OFFICE OF ENVIRONMENTAL SUSTAINABILITY

INSPECTOR'S REPORT ON AN APPLICATION FOR A CERTIFICATE OF AUTHORISATION FOR A CLOSED LANDFILL

TO:	Mr Tom Ryan, Director	
FROM:	Ewa Babiarczyk, Inspector,	Environmental Licensing Programme
DATE:	10 th June 2021	
RE:	Application by Mayo County Council for a Certificate of Authorisation for a closed landfill at Kilbeg, Claremorris, County Mayo . Certificate of Authorisation Register Number H0319-01 .

Figure 2: Site layout and the extent of deposited waste

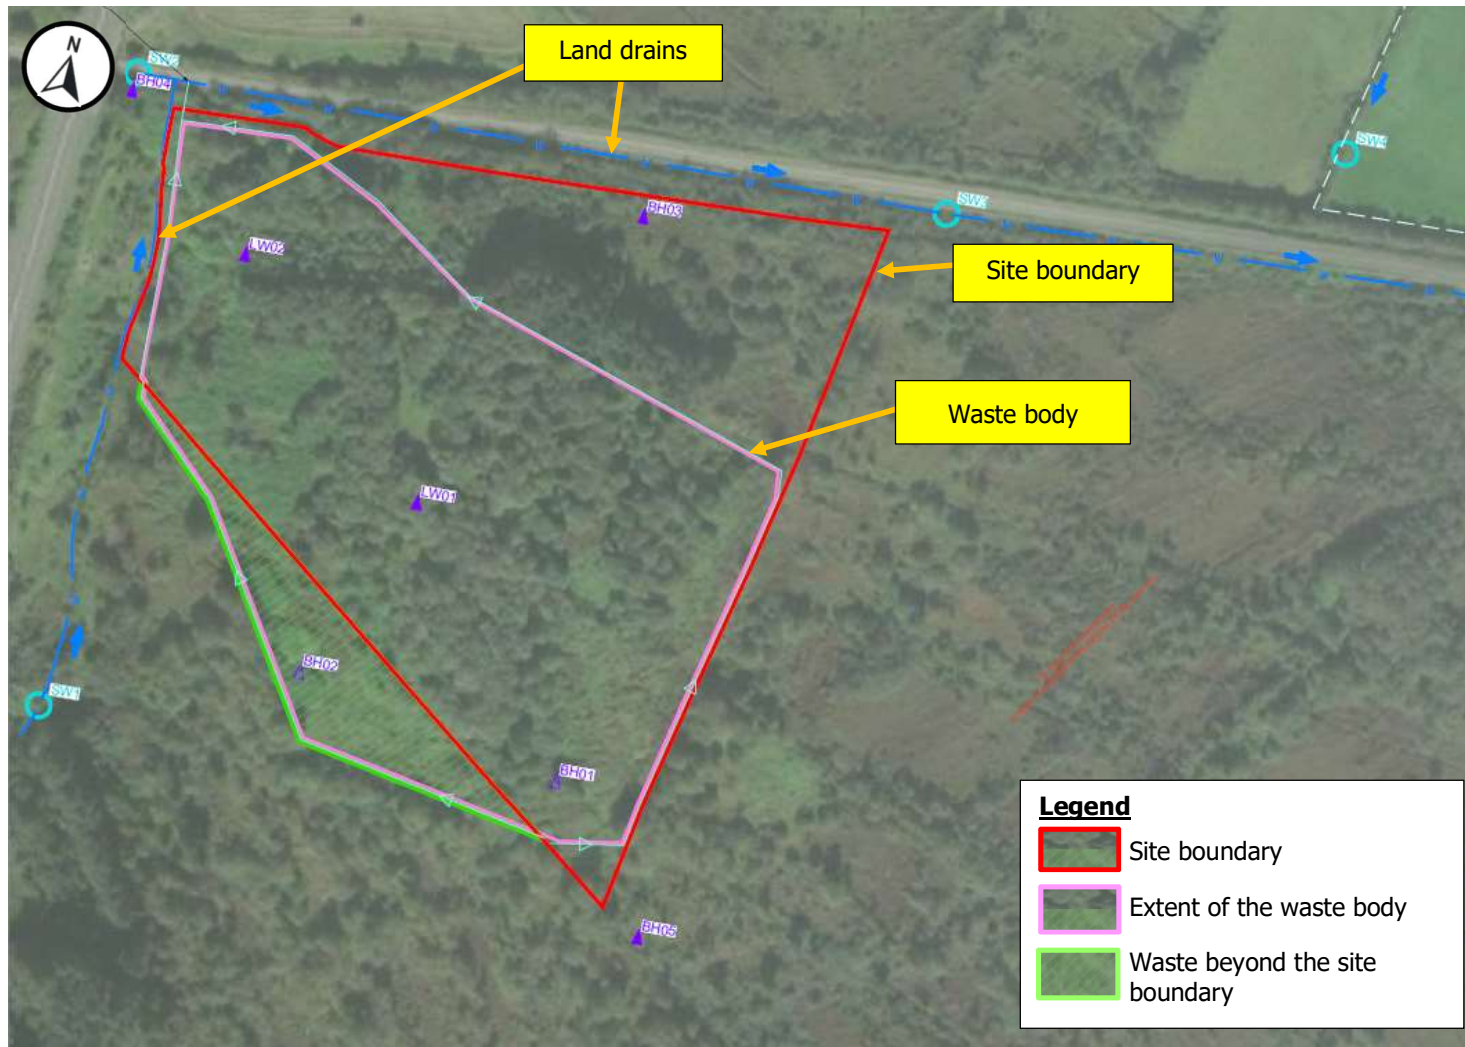
Area of the closed landfill	The site covers an area of approximately 6 ha. The waste body extends beyond the site boundary into privately owned land, as shown in Figure 2. The applicant proposes to cap the waste body, including the waste beyond the site boundary, as outlined in Section: <i>Proposed Remedial Actions</i> of this Inspector's Report. It is noted that the site boundaries shown in Figure 1 and Figure 6 of this report are different to the site boundary shown in Figure 2 and Figure 5. The applicant revised the site boundary, as shown in Figures 2 and 5, in the correspondence received on 23 rd February 2021.
Quantity of waste at the facility	Approximately 279,623 tonnes (199,731 m ³)
Characterisation of waste deposited	The waste comprises municipal waste and construction & demolition (C&D) waste. The encountered waste includes peat mixed with domestic waste, plastic, paper and concrete insulation. The extent of the waste body is 3.8 ha, as shown in Figure 2.

<p>Proposed remedial actions:</p>	<p>Tier 3 Assessment recommends the following remedial measures as the feasible options:</p> <p>1. Landfill cap</p> <p>The Tier 3 Assessment recommends that the landfill capping covers the entire waste body, as shown in Figure 2, and comprises of the following elements, or equivalent:</p> <ul style="list-style-type: none"> (i) 200mm topsoil layer; (ii) 800mm subsoil layer; (iii) 0.5m thick drainage layer of a hydraulic conductivity of a minimum 1×10^{-4} m/s, or equivalent such as a geocomposite; (iv) 1mm LLDPE barrier layer, or equivalent; and (v) landfill gas collection geocomposite. <p>The Tier 3 Assessment also states that the cap will be required to support any on-site solar farm infrastructure, providing a suitable base for the solar panel array.</p> <p>It is noted that the purpose of the landfill cap as specified in the Certificate of Authorisation is to limit the ingress of rainwater and generation of landfill leachate, the integrity of which should not be</p>

impacted by the solar farm infrastructure. Condition 3.4 requires that the integrity of the landfill cap shall be maintained at all times and shall not be compromised by the installation of any future developments.

Figure 5: Surface water, leachate, groundwater and gas monitoring boreholes

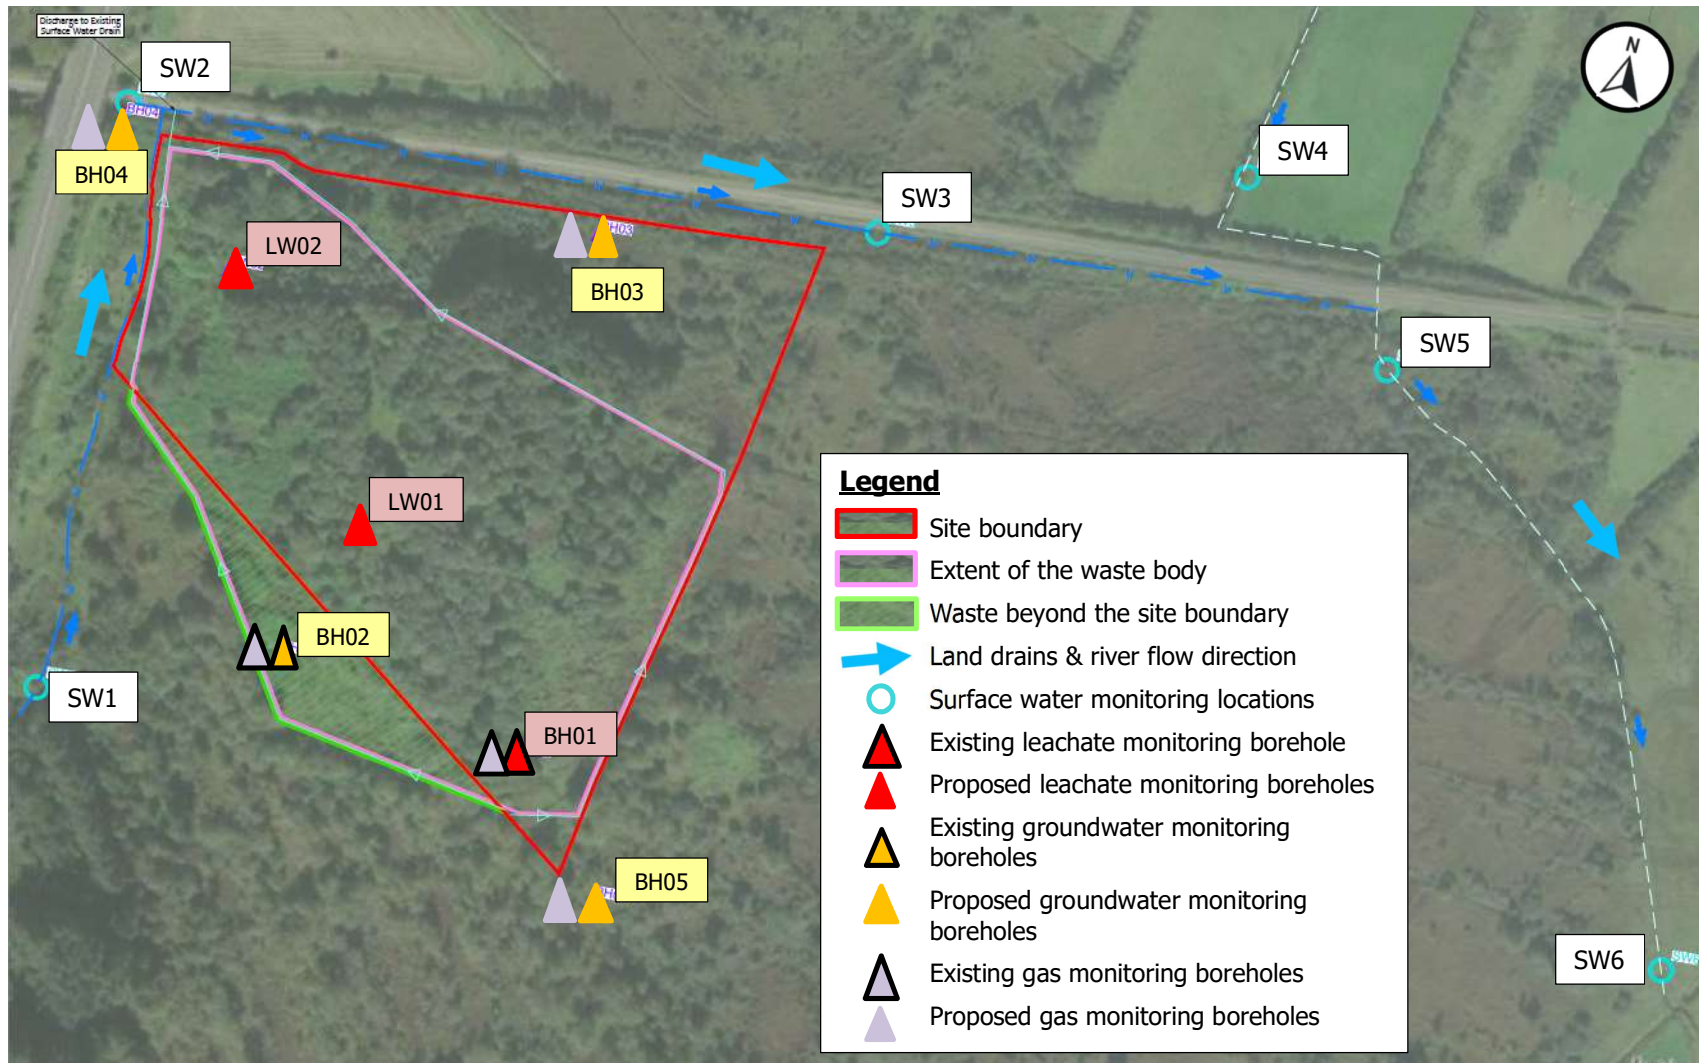
2010 and 27th November 2020, as shown in Figure 5, and that groundwater monitoring was carried out at combined monitoring borehole BH02 on the same dates. It is noted however that BH02 is located within the waste body, close to the southern edge, as shown in Figure 5. Tier 3 Assessment states that waste appears to be tapering to 0.80m at BH02 and that groundwater level was present at 0.785m below the surface. The Tier 3 Assessment further states that it can be assumed that groundwater intersects the waste body further upgradient.

The Tier 3 Assessment recommends surface water monitoring at six locations SW1, SW2, SW3, SW4, SW5 and SW6, as shown in Figure 5. Additionally, as outlined in Section: *Hydrology* above, one additional monitoring location is required on the Lisduff River (monitoring location south-east of the closed landfill (SW7)).

The Tier 3 Assessment recommends monitoring of leachate at the locations LW01 and LW02 within the waste body, as shown in Figure 5. Condition 3.9(b) reflects this recommendation and, in addition, requires leachate monitoring at the existing monitoring location within the waste body BH01.

The Tier 3 Assessment recommends that groundwater is monitored at the existing borehole BH02, upgradient of the waste body at the proposed monitoring borehole BH04 and downgradient of the waste body at the proposed monitoring boreholes BH03 and BH05, as shown in Figure 5. It is noted however that borehole BH03 may not be fully representative of the downgradient groundwater conditions. Accordingly,

The Tier 3 Assessment recommends monitoring of landfill gas at the existing boreholes BH01 and BH02 within the waste body and the three proposed monitoring boreholes BH03, BH04 and BH05 outside the waste body, as shown in Figure 5. Accordingly, Condition 3.1(f) requires installation of the additional gas monitoring locations BH03, BH04 and BH05. Condition 3.9(d) requires a quarterly monitoring to detect the presence and concentration of landfill gas at BH01, BH02 and the three proposed boreholes.

Condition 3.1(g) requires installation of one additional groundwater monitoring borehole (BH06) downgradient of the waste body. Condition 3.9(f) requires monitoring of groundwater at the above locations on a quarterly basis and specifies the minimum parameters to be monitored.

Figure 7: Conceptual site model for Claremorris Historic Landfill

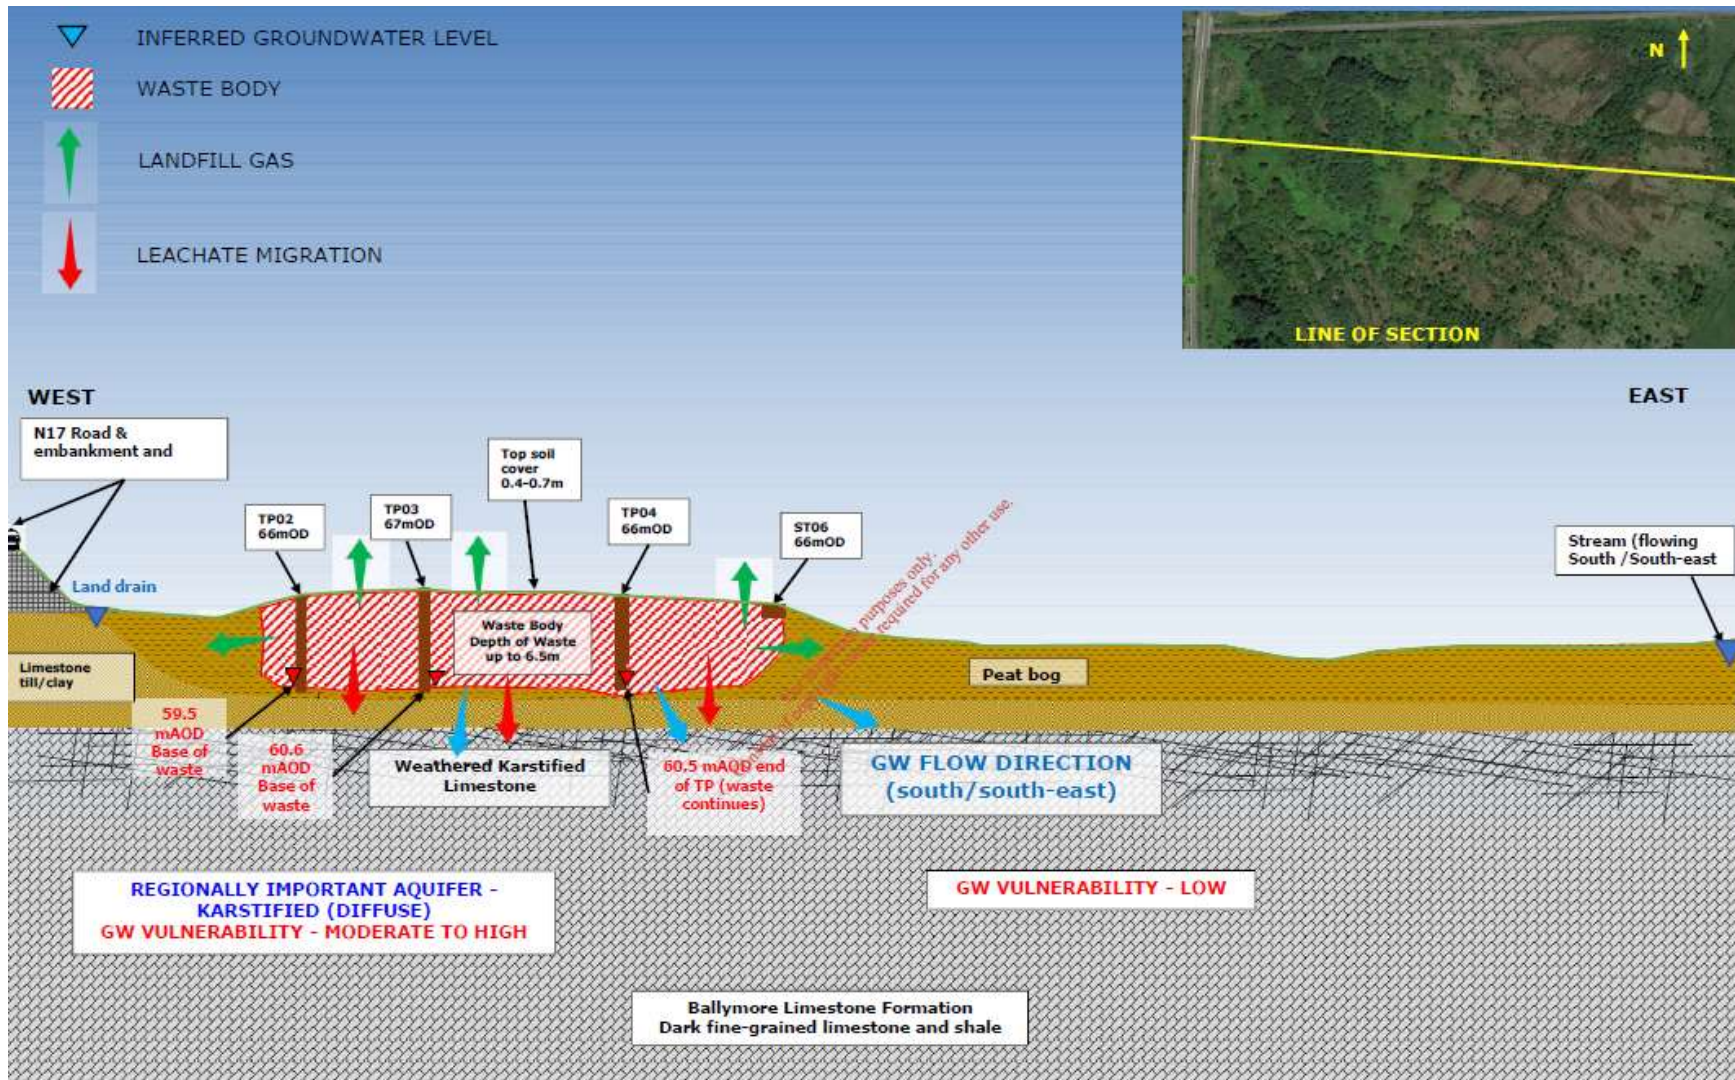
Conceptual site model:	<p>Tier 1 and 2 Assessment determined that the overall risk score for the closed landfill was Moderate (Class B) due to leachate migration into the underlying aquifer and, via groundwater, to human receptors and surface waters.</p> <p>Tier 2 and Tier 3 Assessments confirmed this classification due to leachate migration into the underlying aquifer.</p> <p>The conceptual site model is shown in Figure 7.</p>
